**ADDENDUM NO. 4**

**CHELSEA**

**Construction of the Silverline Gateway Busway,  
BRT Stations and Bridge Replacement (Steel) Br. No. C-09-001  
Washington Avenue over the MBTA Railroad**

**RESPONSE TO CONTRACTOR QUESTIONS**

STATE	FED AID PROJ. NO.	SHEET NO.	TOTAL SHEETS
MA	-	212	346
PROJECT FILE NO.		604428

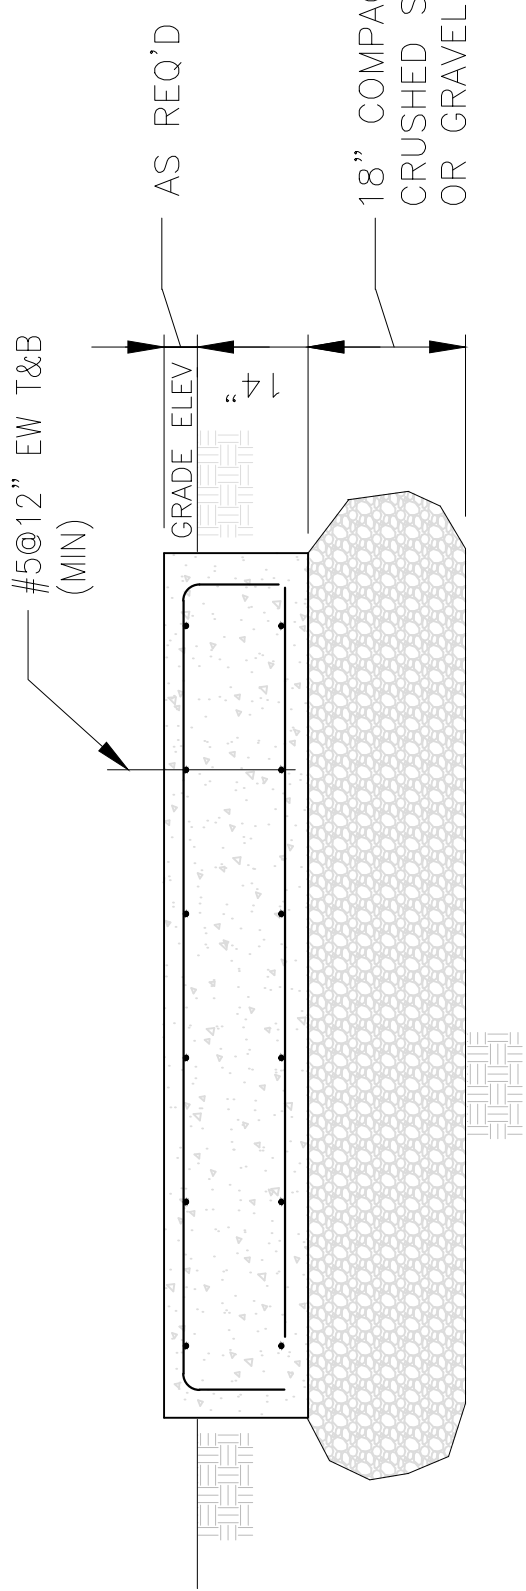
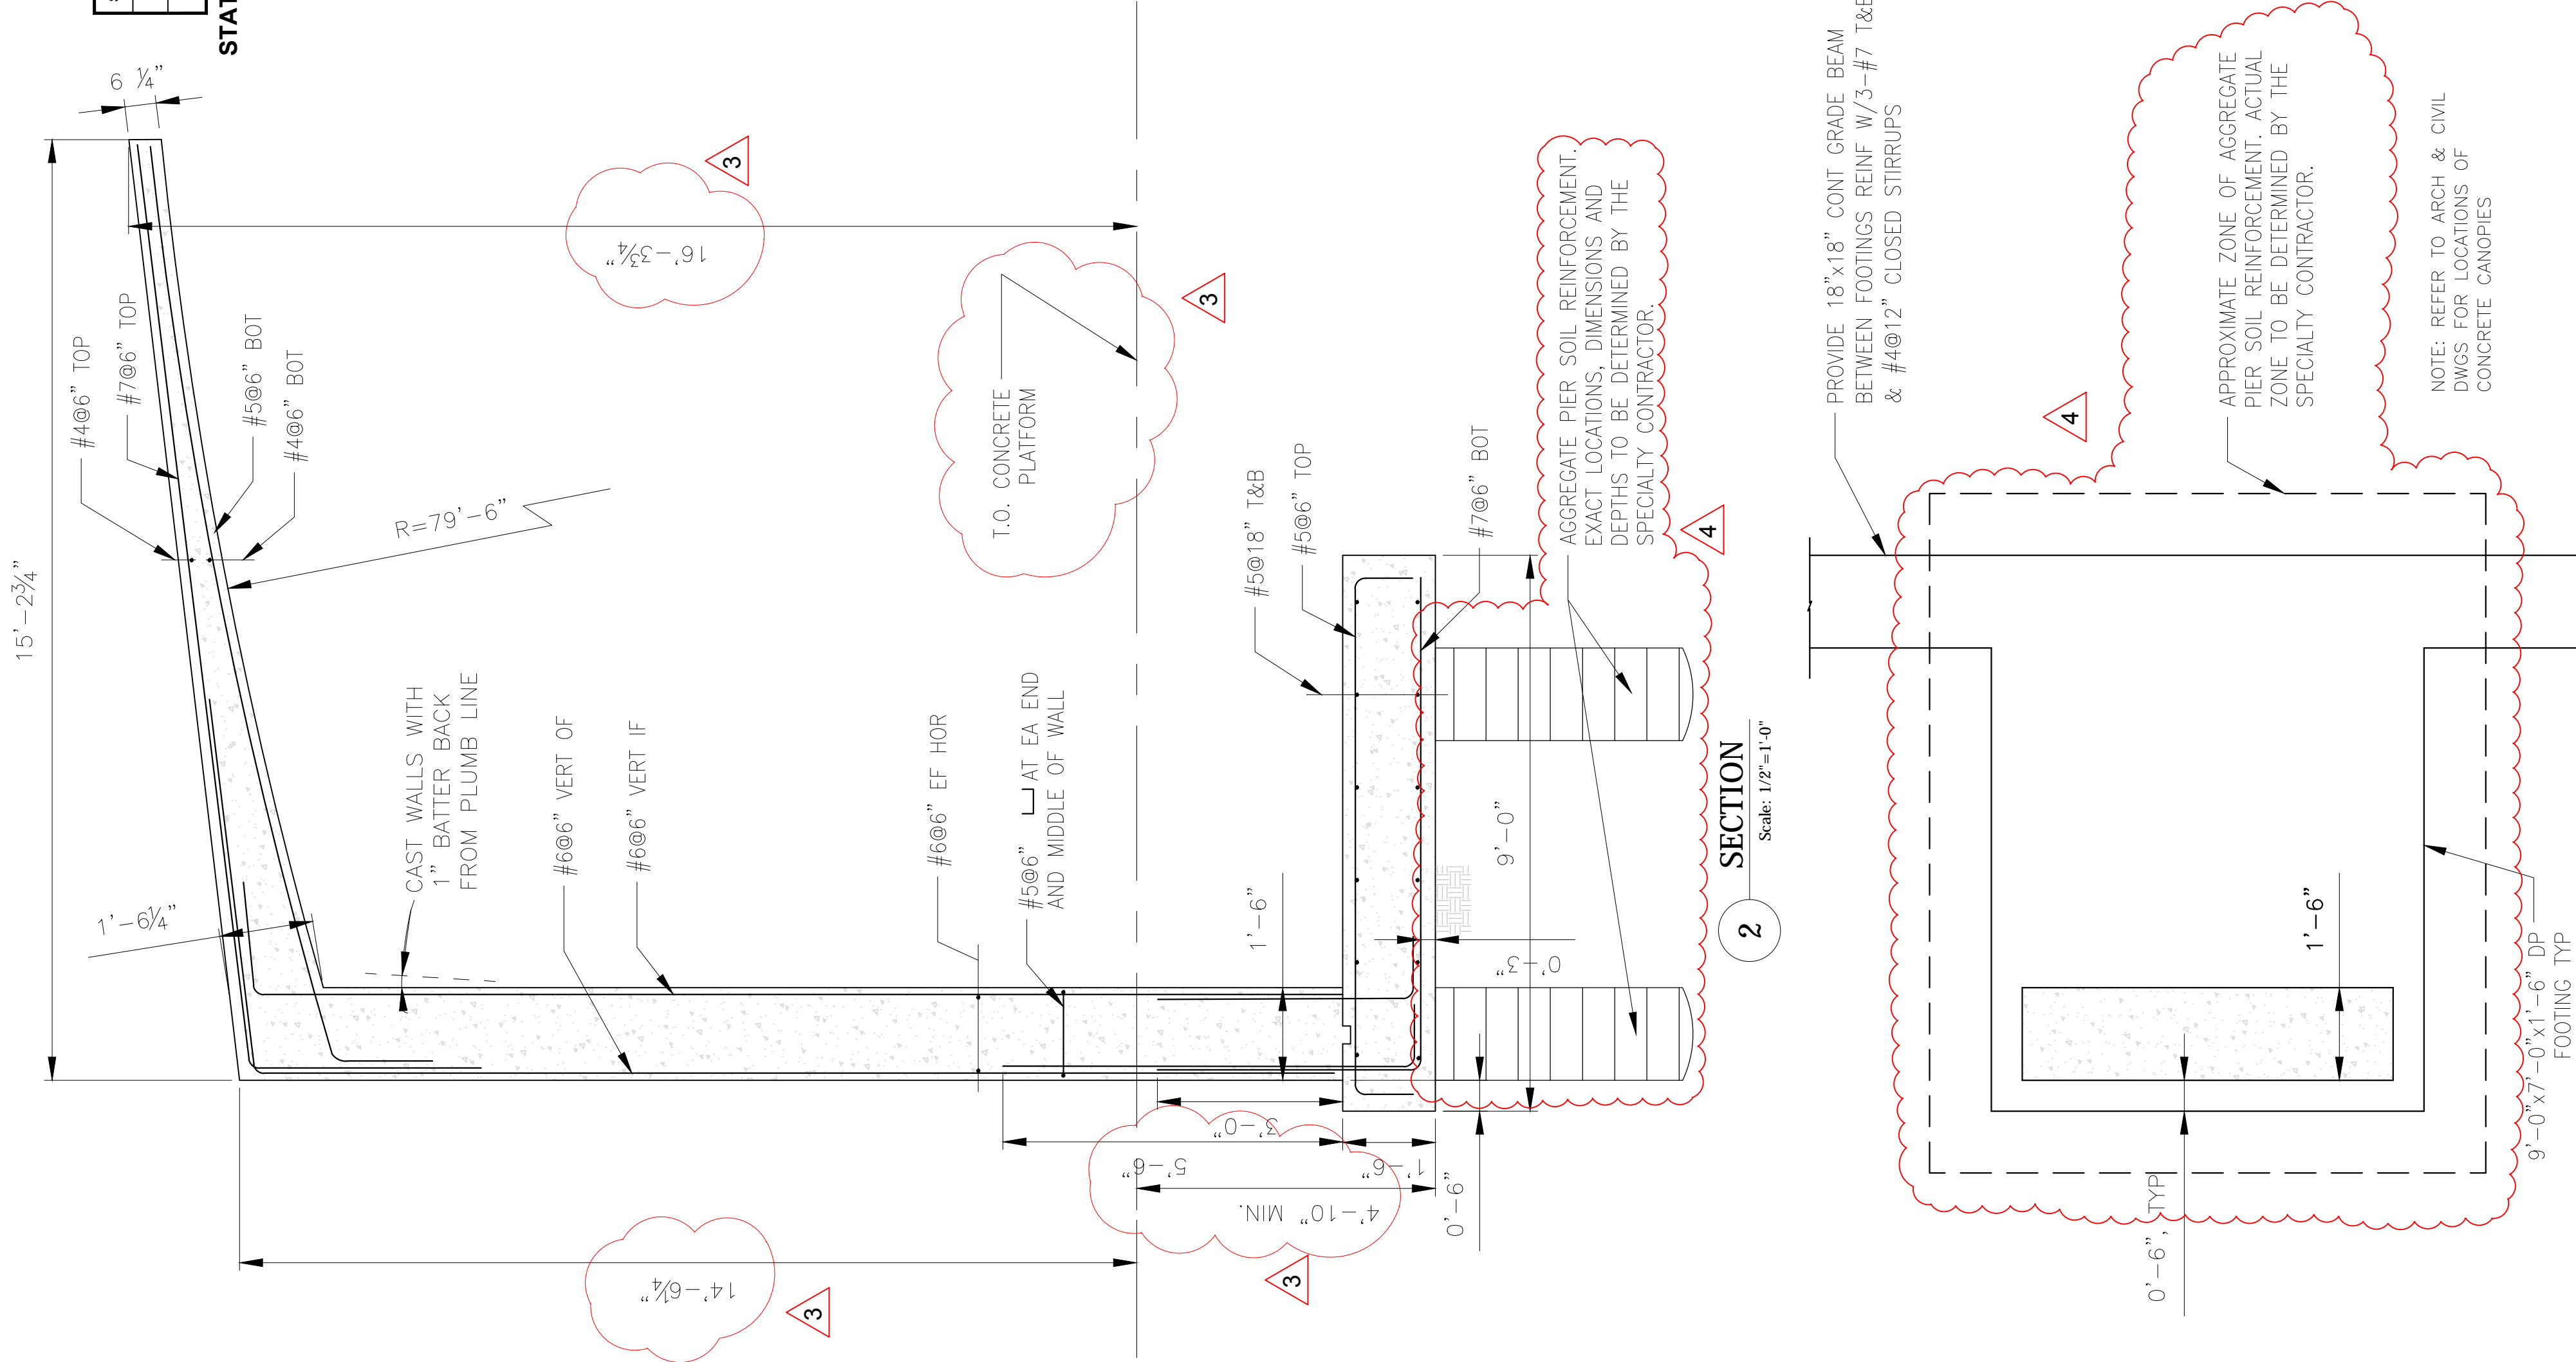
**Question 59)** Newly-added Specification Section 02195 states “Aggregate Pier soil reinforcement is required below various structures for this project as noted on the foundation plan sheets.” There are no notes on any of the foundation plan sheets mentioning this work. Which structures is this required for?

**Question 67)** Addendum 3 provided Specification Section 02195 Ground Improvements Page A-00803-7.9 para. 1.1 states “ The work shall consist of designing, furnishing, and installing aggregate pier ground improvement to the lines and grades designated on the project foundation plan and as specified herein”. Please provide the sheet numbers for these foundation plans and/or advise which structures this work is required for.

**Question 79)** Are there drawings and/or details available for section 02195 – Ground Improvement - Aggregate Piers added in Addendum 3?

**Response 59)** The Ground Improvement – Aggregate Piers work is for the cast in place concrete upright foundations for the canopy structures at 3 of the BRT Stations. Refer to the revised Specification Section 02195 included with this Addendum No. 4.

**Response 67)** Specification Section 02195 and drawing Sheet 212 have been revised as part of this Addendum No. 4.

**Response 79)** Design of the Aggregate Pier Ground Improvement is a performance based system to be designed and constructed by a specialty contractor. Refer to the revised Specification Section 02195 included with this Addendum No. 4 and notes added to Sheet 212.
